Up-armored
HMMWVs...

CONDENSER FAN ASSEMBLY CHANGES

Improved rear condenser allows for more clearance and has stronger panel

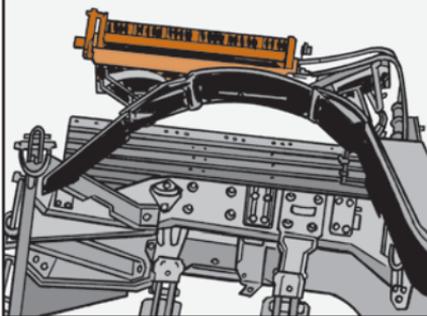
AN UPGRADED REAR AIR CONDITIONER CONDENSER IMPROVES YOUR M1151, M1152, AND M1165 BASIC AND -A1 UP-ARMORED HMMWVs.

THIS NEWER CONDENSER ALLOWS FOR MORE CLEARANCE, HAS A BEEFED-UP CLOSEOUT PANEL, AND SHOULD CURB POTENTIAL DAMAGE.

The original rear condensers, NSN 4130-01-537-4847 and NSN 4130-01-536-5561, are no longer available. But you can get the replacement condensers, closeout panel and related hardware in upgrade kits that TACOM LCMC assembled.

Order the left-hand rear condenser kit using NSN 2540-01-558-3448, and the right-hand rear condenser kit using NSN 2540-01-558-3450.

Two fans that pull the air through are mounted underneath the condenser. Get the front condenser fan with NSN 4140-01-548-2496 and the rear condenser fan using NSN 4140-01-548-1171.

Make a note of these NSNs in the TM until it's updated.
